PLATEAU MINING COMPANY

August 16, 1983

Re: NOV 83-4-7-3

SECTION A-A
N.T.S.

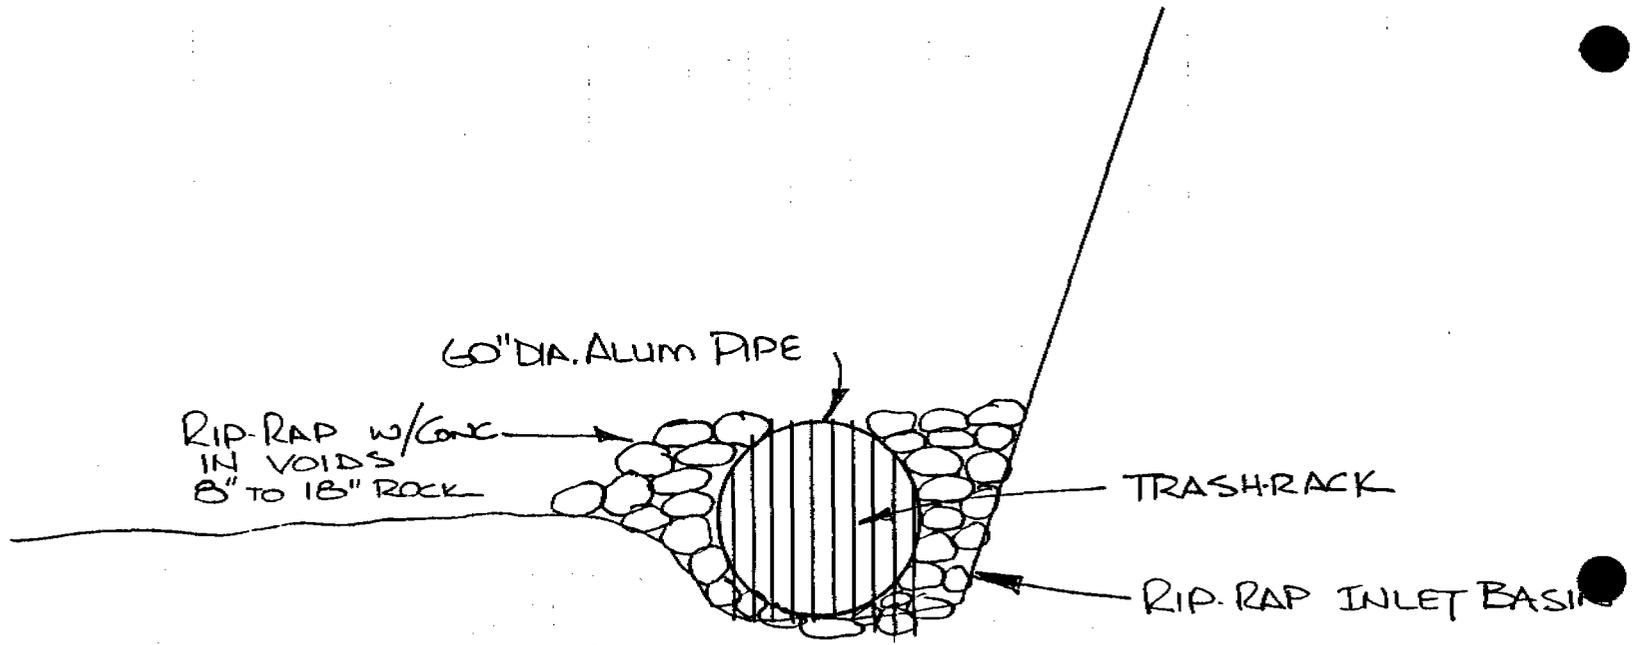
We would ask then, for a variance from the approved plan to use rip-rap with a mean size of 1.083 ft. In addition, concrete will be placed in the voids around the rip-rap to hold the rock in place. The concrete will bond the rock into a mass, preventing any rocks from being washed down the ditch.

SECTION B-B
N.T.S.

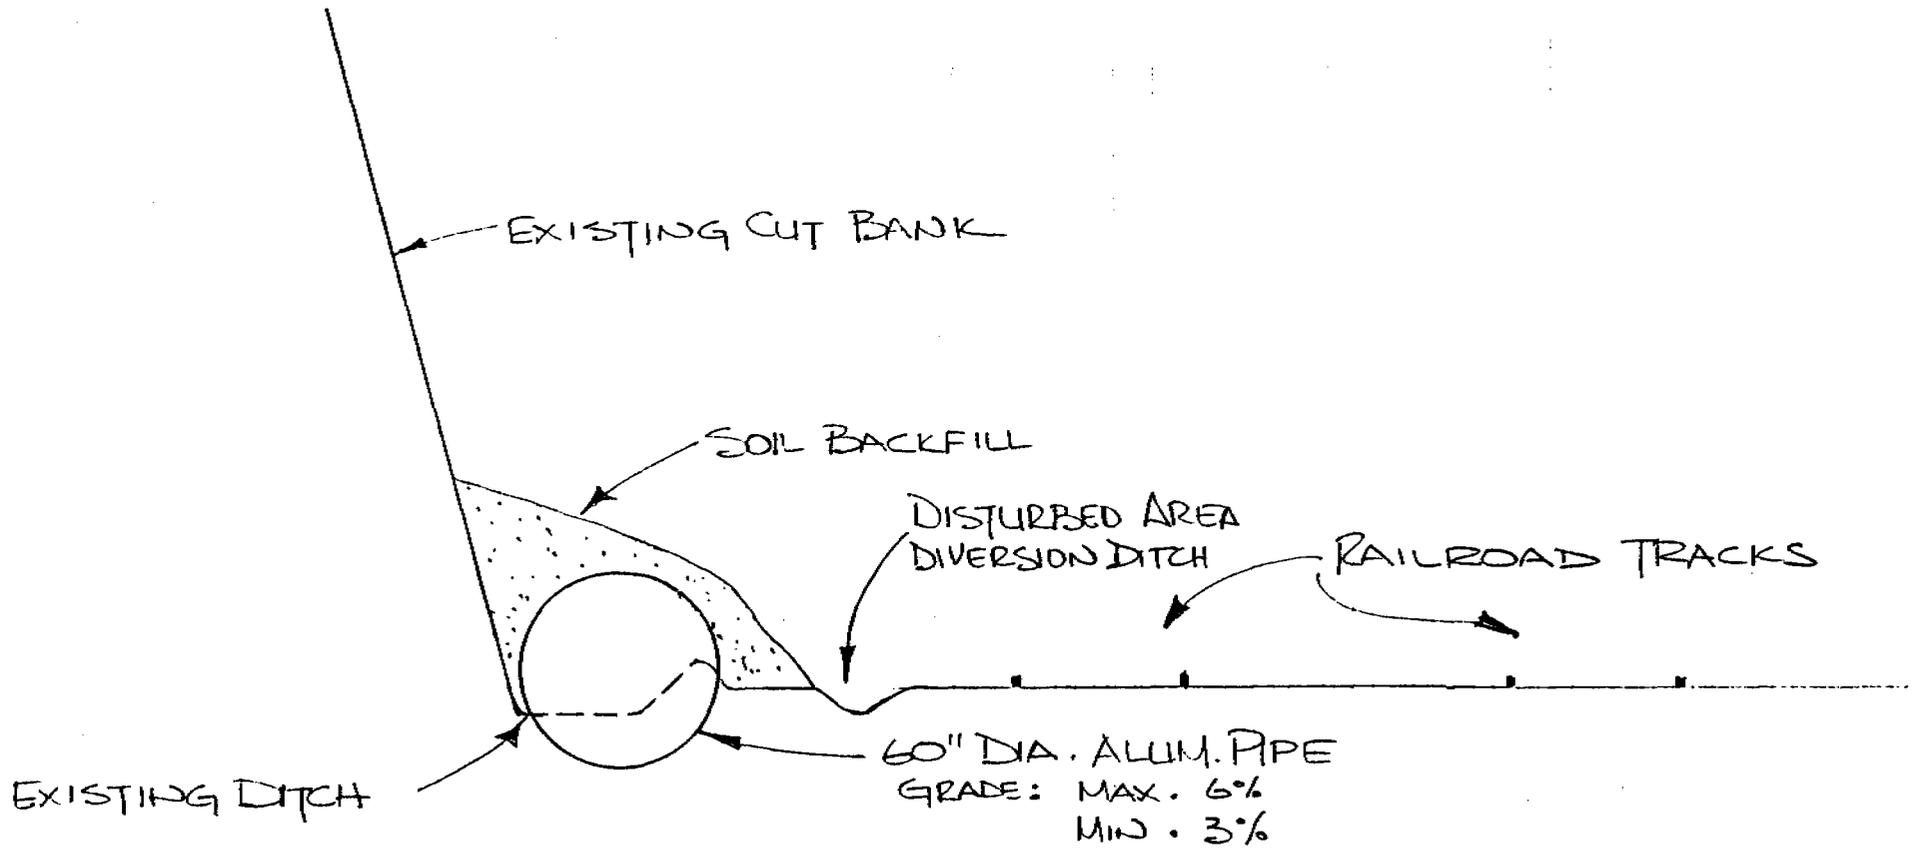
To eliminate contribution of suspended solids occurring from the near vertical cut bank on the south side of the ditch in the upper 300 feet of the yard, we would also propose installing a 60" diameter corrugated aluminum pipe in this area (refer to map and section B-B).
